Title: Advisory Committee on Reactor Safeguards  
Subcommittee on Power Upgrades

Location: Brattleboro, Vermont

Date: Wednesday, November 16, 2005

SUBCOMMITTEE ON POWER UPRATES

### VY Risk Evaluation: Items to Consider – Analysis Method 2

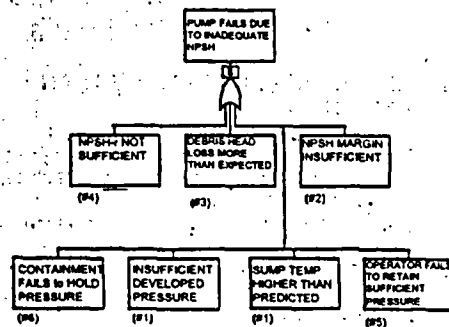
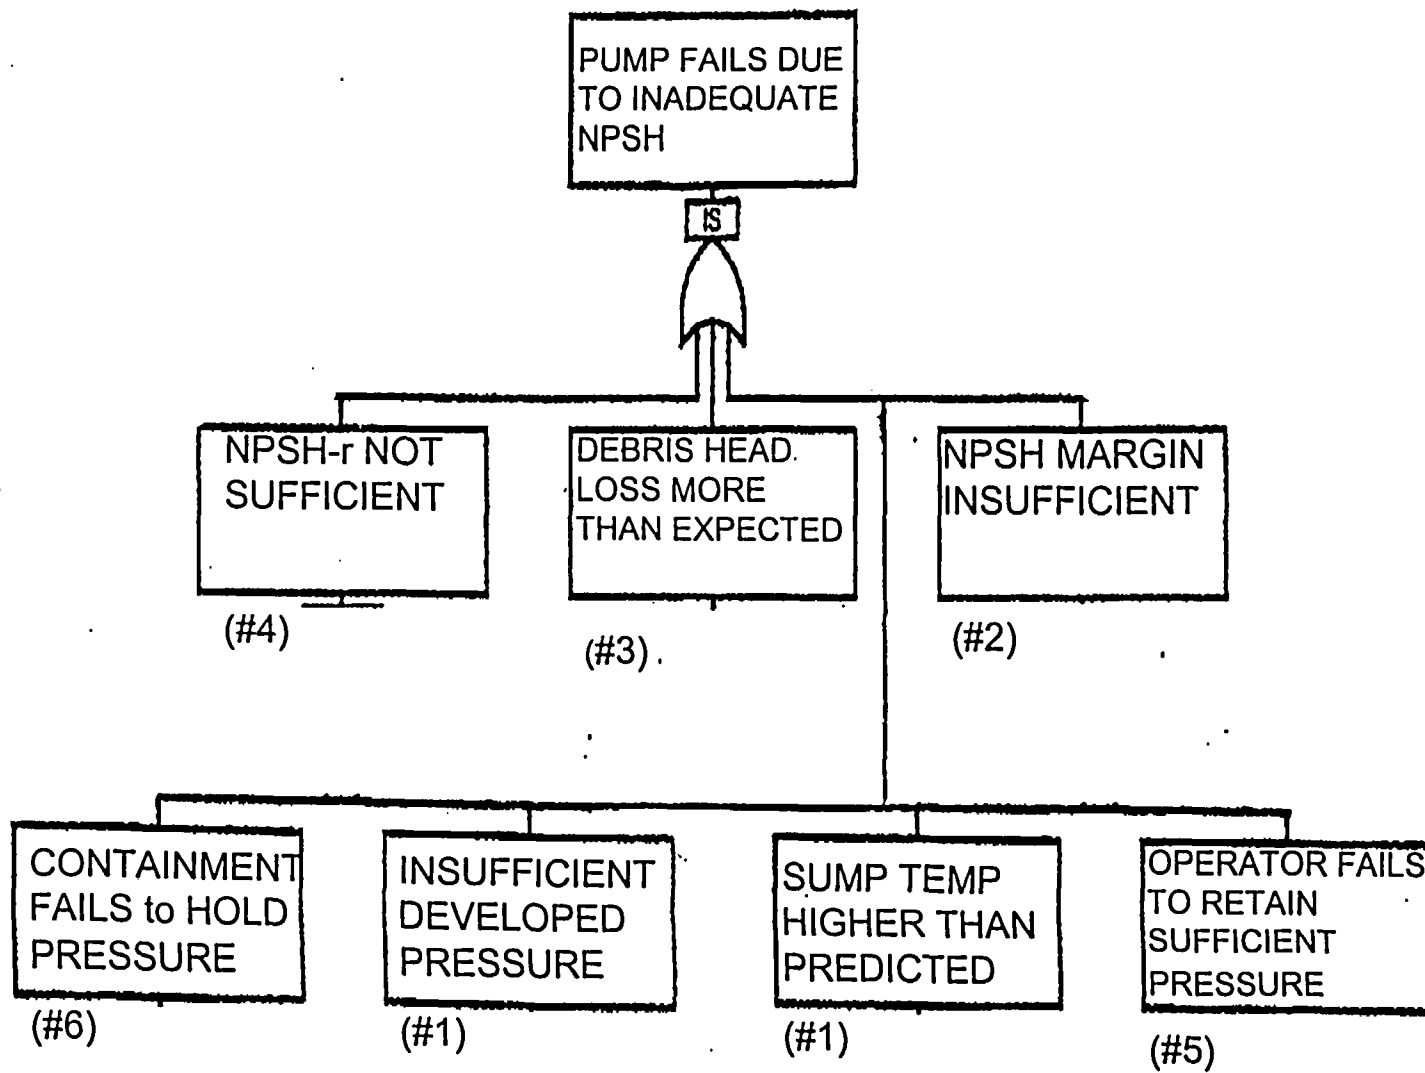
20 MR. SHERMAN: Thank you. The way that we  
21 looked at it, going back to the previous slide,  
22 instead of only the containment pressure available or  
23 not available, we think that for this particular  
24 problem it's the question of whether NPSH failure  
25 using containment over-pressure, and NPSH failure not

- The *Desired Method* would:
  1. Capture the loss of NPSH margin given up by crediting overpressure
  2. Assume in one case that the practical alternative was implemented and in the other case overpressure credited

### VY Risk Evaluation: Items to Consider – Analysis Method 8

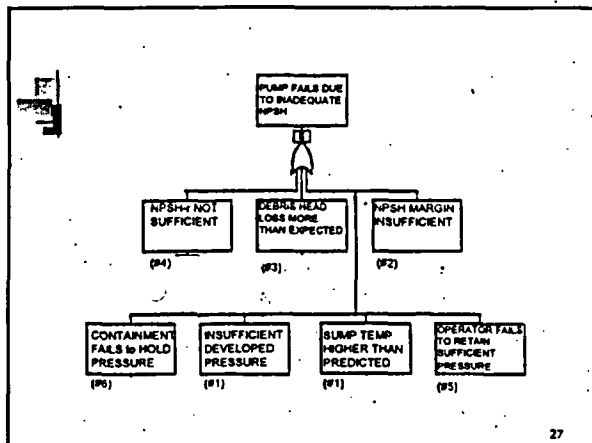
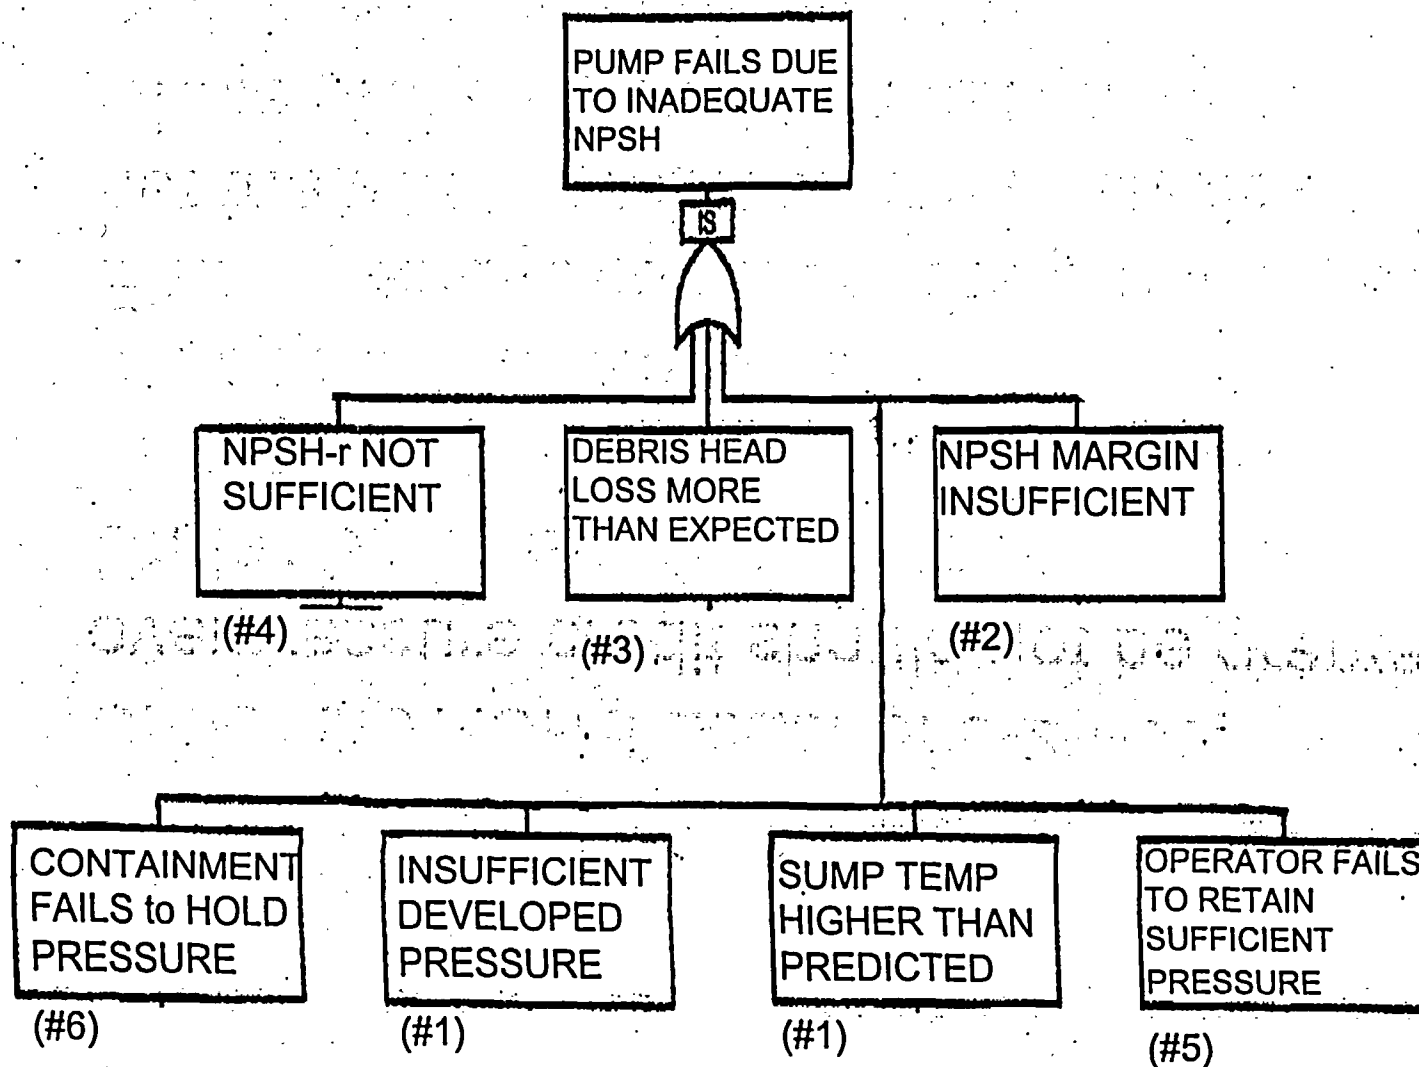
7 The containment fails to hold pressure -  
8 that's the one item that the licensee did, and I've  
9 already identified our comments and questions on the  
10 way that they did that. Two other items, insufficient  
11 developed pressure, and some temperature higher than  
12 predicted - these values have already been calculated  
13 conservatively, so I would imagine these probabilities  
14 would be very low. However, there is some probability  
15 that even these conservative calculations are - if  
16 you're going to assign a probabalistic distribution,  
17 that they're not zero.

- INSUFFICIENT DEVELOPED PRESSURE
  - SUMP TEMP HIGHER THAN PREDICTED
- 1 These values have been calculated conservatively.
  - 2 There is still some probability that each will be less favorable than considered.
